UNITED STATES DEPARTMENT OF COMMERCE United States Patent and Trademark Office Address: COMMISSIONER FOR PATENTS P.O. Box 1450 Alexandria, Virginia 22313-1450 www.uspto.gov

APPLICATION NO.	FILING DATE	FIRST NAMED INVENTOR	ATTORNEY DOCKET NO.	CONFIRMATION NO.
10/598,821	07/10/2007	Hermann Wetter	3144/121US	1701
23638 7590 03/24/2009 ADAMS INTELLECTUAL PROPERTY LAW, P.A. Suite 2350 Charlotte Plaza			EXAMINER	
			LAVINDER, JACK W	
201 South College Street CHARLOTTE, NC 28244			ART UNIT	PAPER NUMBER
			3677	
			MAIL DATE	DELIVERY MODE
			03/24/2009	PAPER

Application No.	Applicant(s)			
Office Action Comments	10/598,821	WETTER, HERMANN			
Office Action Summary	Examiner	Art Unit			
	Jack W. Lavinder	3677			
The MAILING DATE of this communication appears on the cover sheet with the correspondence address Period for Reply					
A SHORTENED STATUTORY PERIOD FOR REPLY IS SET TO EXPIRE 3 MONTH(S) OR THIRTY (30) DAYS, WHICHEVER IS LONGER, FROM THE MAILING DATE OF THIS COMMUNICATION. - Extensions of time may be available under the provisions of 37 CFR 1.136(a). In no event, however, may a reply be timely filed after SIX (6) MONTHS from the mailing date of this communication. - If NO period for

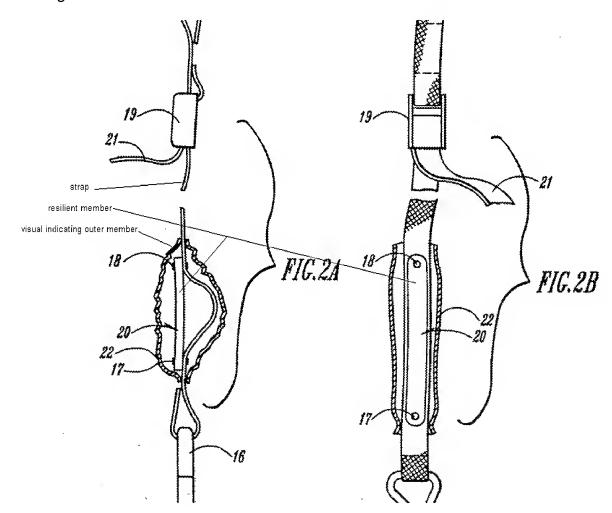
Claims 1, 2, 4-6, 22 and 23 have been rejected under 35 U.S.C. 102(b) as being anticipated by Allen, 5738259. Allen discloses the claimed invention as shown in the annotated drawing.
